1982 Service Manual Up-Date

All Models Except
Firenza

1982 SERVICE MANUAL UPDATE

This manual provides corrected or additional information that was not included in the 1982 Chassis Service Manual and the 1982 Omega and Cutlass Ciera Service Manual. In cases where information can-not easily be added to a service manual, it is suggested that a notation be made in that particular service manual to refer to this manual.

Fig. 8A-8—Booster Low Vacuum Switch

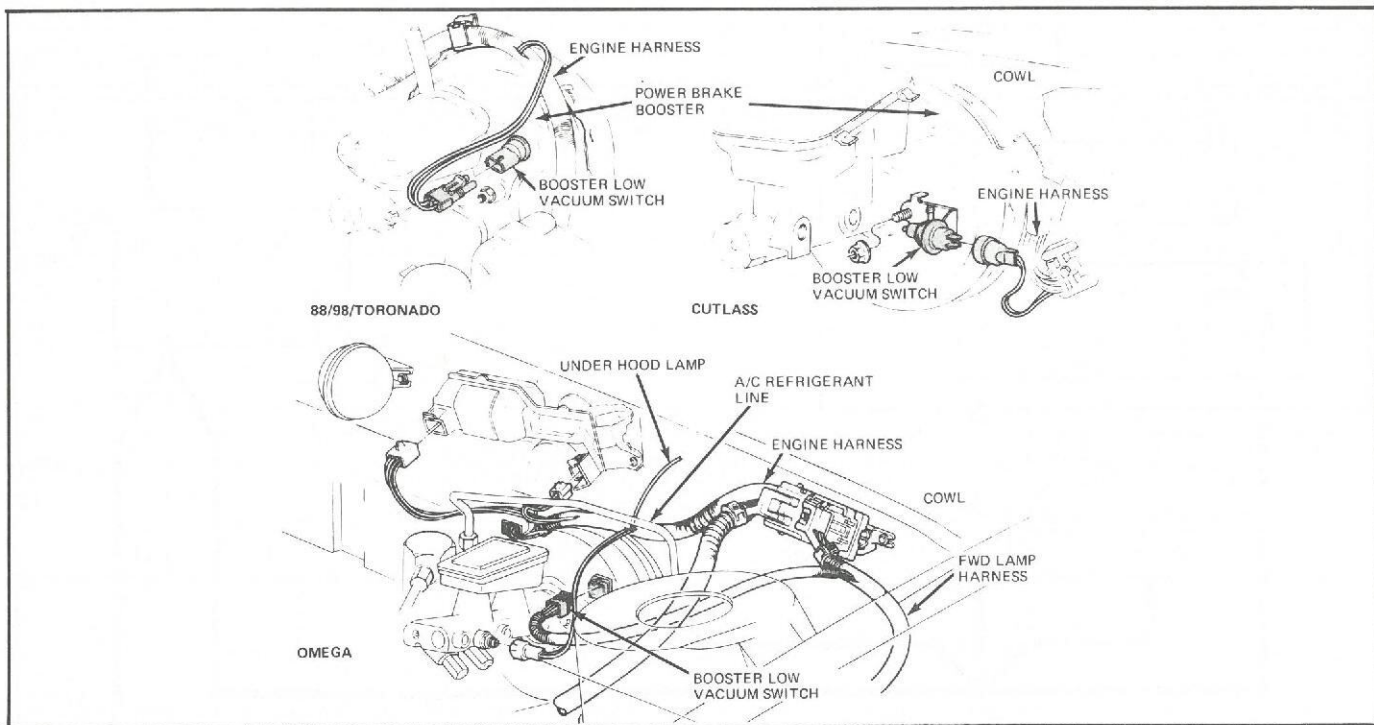
Figure 1 on page 115 of the Electrical Troubleshooting Manual (ETM) shows the incorrect location of the Booster Low Vacuum Switch. Figure 8A-8 shows the correct location of the switch on Cutlass models.

Switch is missing. Figure 8A-8 shows the switch location for these models.

Page 8A-338 of the Omega/Cutlass Ciera Service Manual shows the Booster Low Vacuum Switch. Figure 8A-8 will supplement this information by showing the exact location of the switch on the car.

Fig. 8A-11—Computer Command Controls (Vehicle Sensors, TCC) –V6 'A' Car

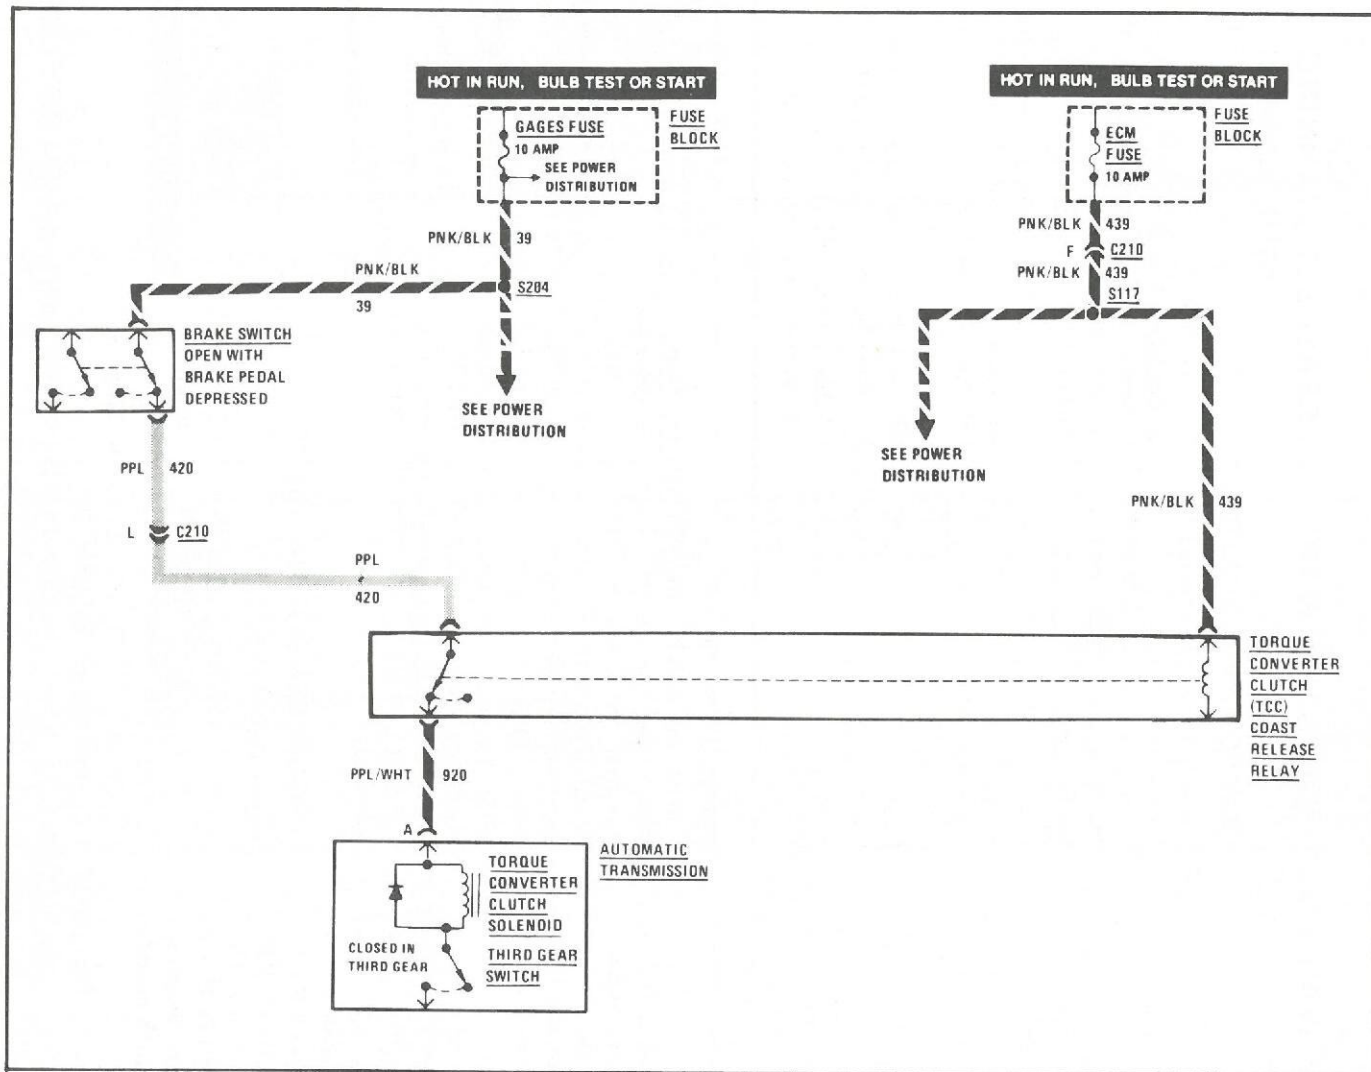
A change has been made in the Torque Converter Clutch (TCC) circuit on Cutlass Ciera models with the V-6 gasoline engine. Figure 8A-11 shows the new wiring for the TCC Coast Release Relay and should be used in place of the relay circuitry found on page 8A-124 of the Omega/Cutlass Ciera Service Manual.

Fig. 8A-13—Cutlass Ciera I/P Clock

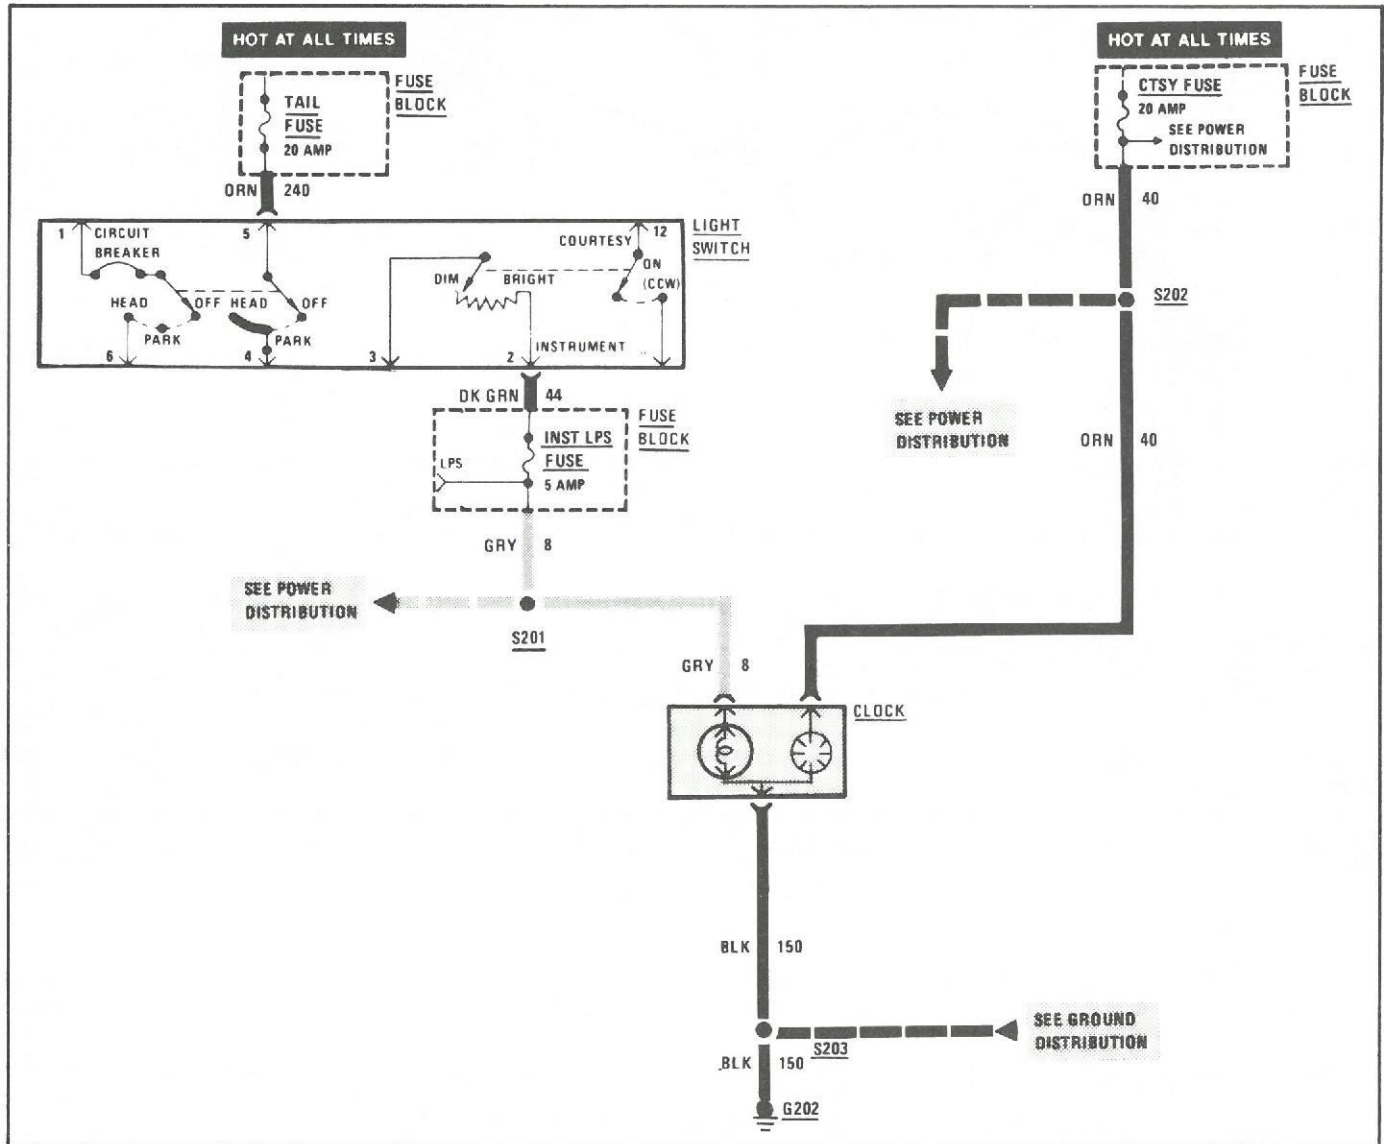
Instrument panel mounted clocks are now available as optional equipment (option codes UE8 and U35) on Cutlass Ciera models. Figure 8A-13 is the circuit diagram for the clock circuit. Refer to this diagram when troubleshooting instrument panel mounted clocks only. When troubleshooting digital clocks found in the radio, refer to pages 8A-198 through 8A-200 in the Omega/Cutlass Ciera Service Manual.

Fig. 8A-14—Audio Alarm System (Chime/Buzzer)

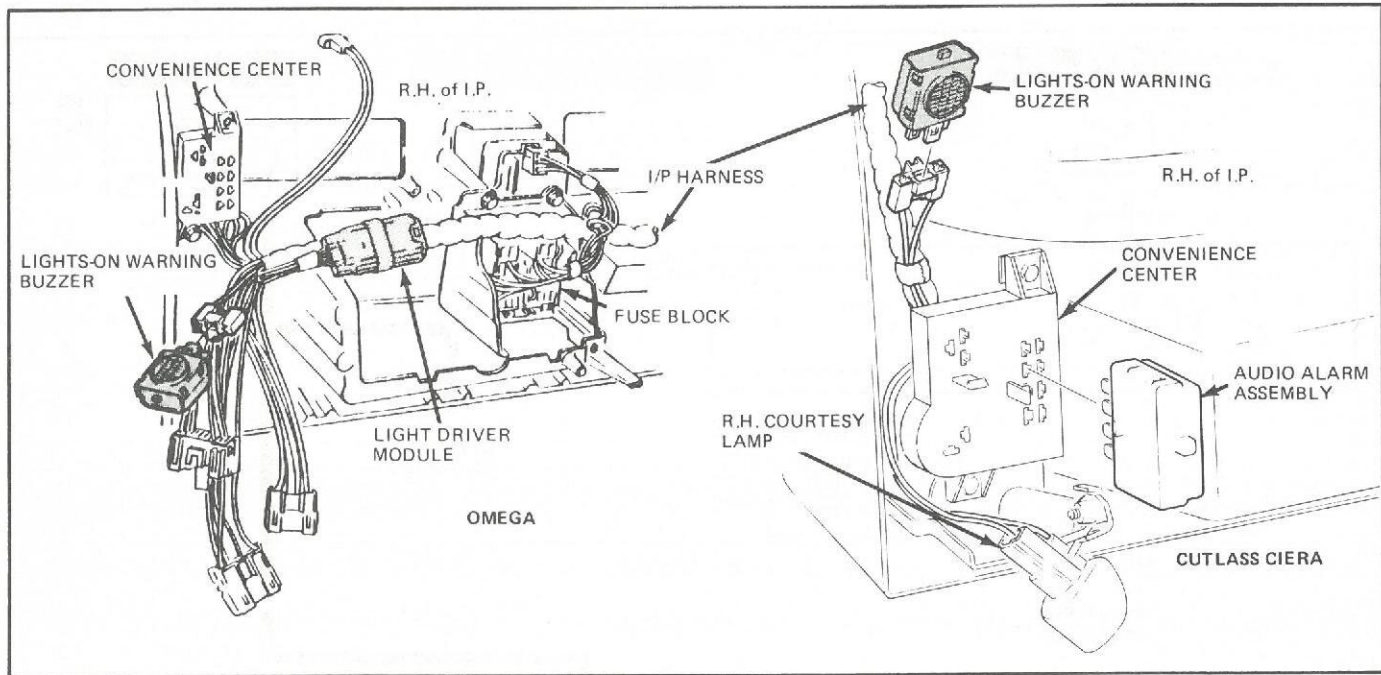
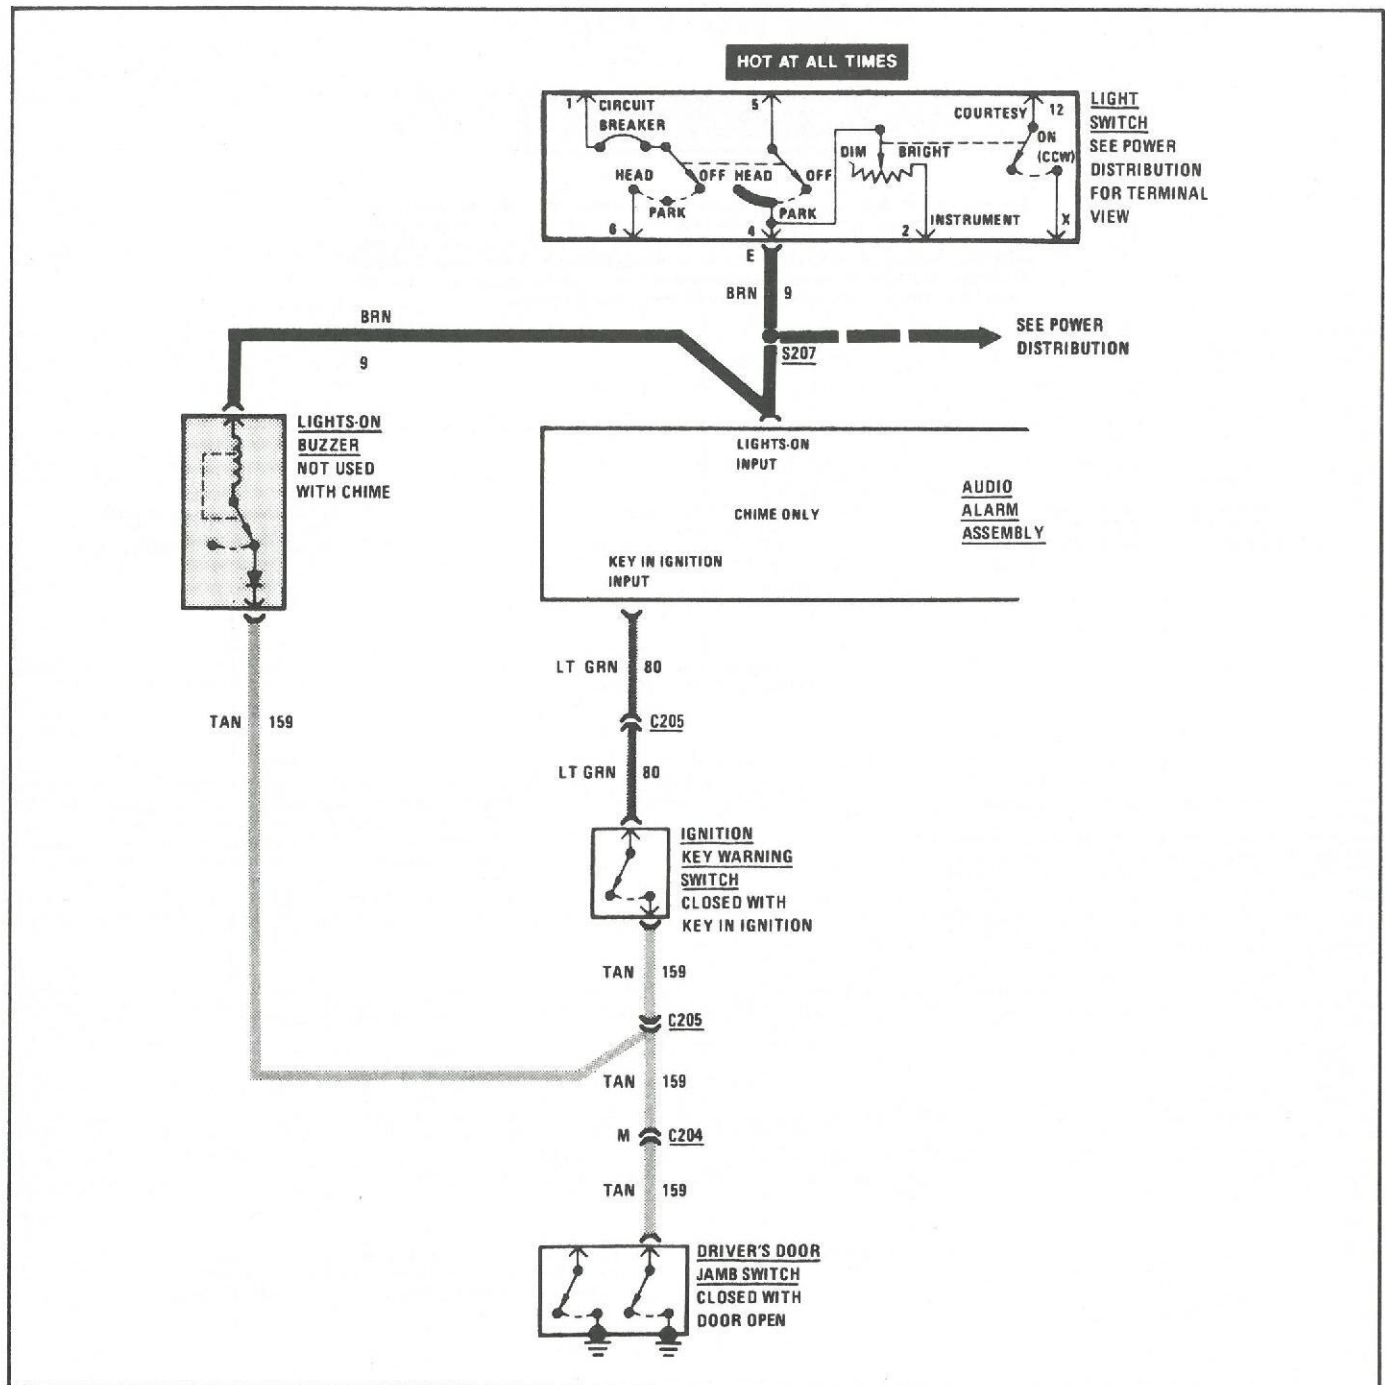
separate unit from the Audio Alarm Assembly as shown in Figure 8A-14. The wiring of the separate Lights-on buzzer portion of the Audio Alarm System is shown in 8A-15. Lights-on buzzer component location for Cutlass Ciera is also shown in Figure 8A-14.

Fig. 8A-16—Glow Plug Diagnosis

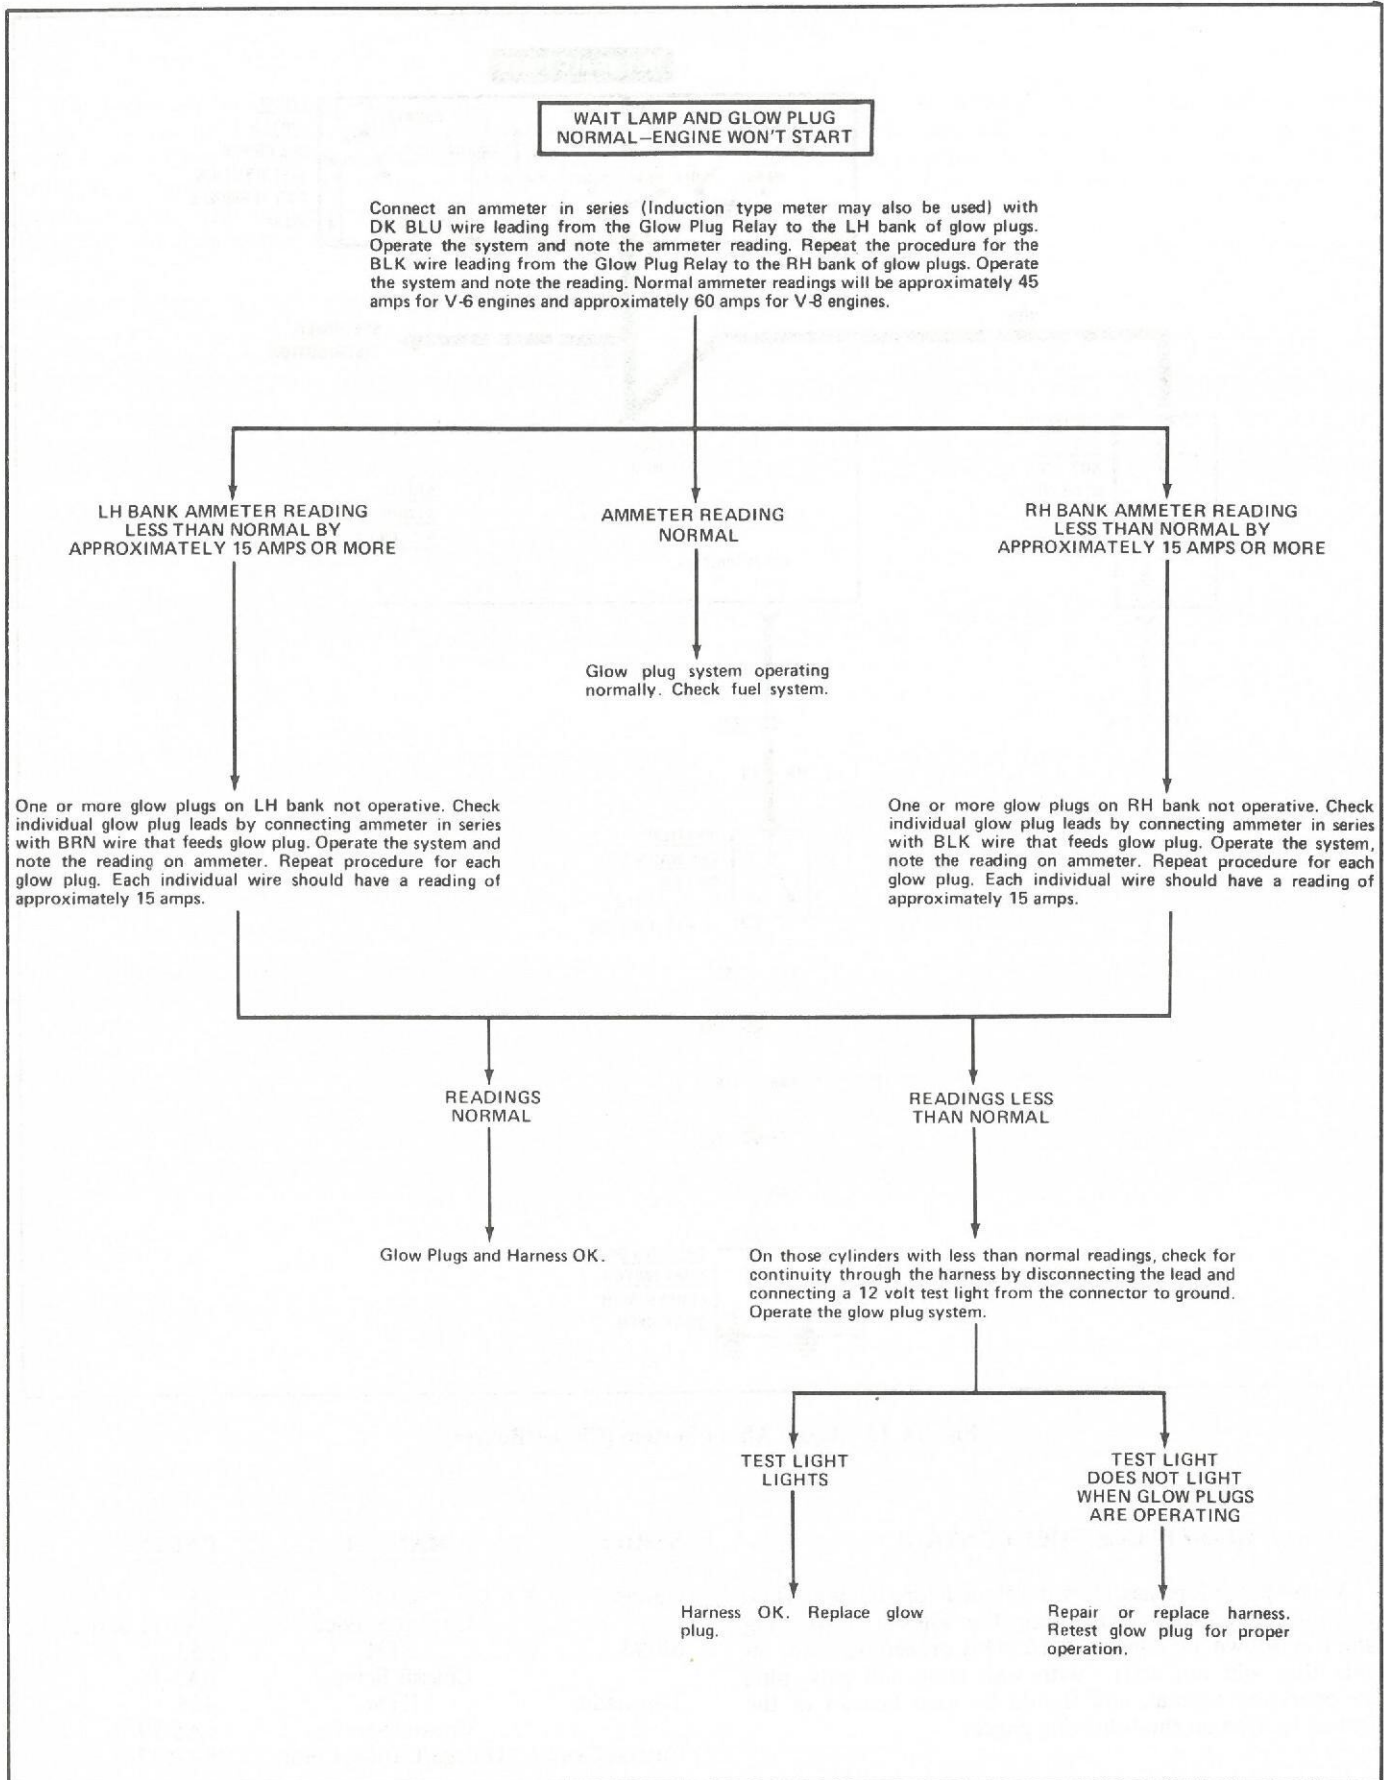
A new procedure has been developed for checking glow plug continuity when diagnosing the Diesel Glow Plug System as shown in Figure 8A-16. This procedure is for an engine that will not start— with wait lamp and glow plug relay operation normal, and should be used instead of the diagnosis located on the following pages:
